**Preliminary Acceptance Punchlist**  
**El Paso County – Department of Public Works - Stormwater Section**

Project Name:	Smith Plumbing, Heating & Cooling
EDARP Filing Number(s):	PPR2143, CON2259
ESQCP Number:	ESQ2249
Attendees:	DPW SW: Natasha Grimaldo and Ben Jones DPW Development Services: Amanda Rivera Developer: Josh Reed, Salvador Valdez, and Todd Jeffers
Date of Walk-Thru:	04/16/2024
Walk-Thru Number:	1 <sup>st</sup>

Photo 4: Pond: Raise pond bottom to top of trickle channel curb with a 3% slope towards trickle channel for positive drainage.

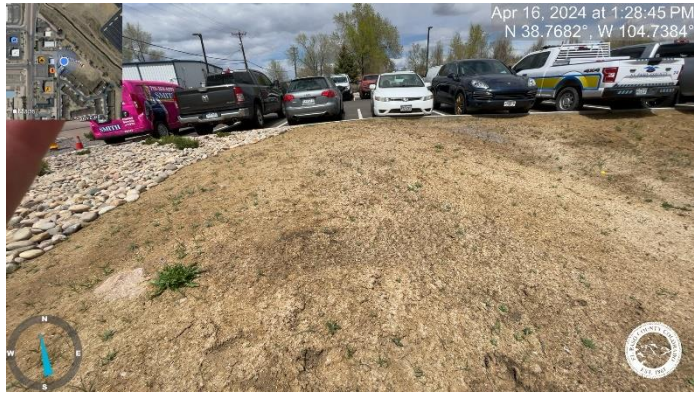
- Eliminate gap between the trash rack and concrete structure. Reference Photo 2.
- Raise pond bottom to top of trickle channel curb with a 3% slope towards trickle channel for positive drainage. Reference Photo 4.
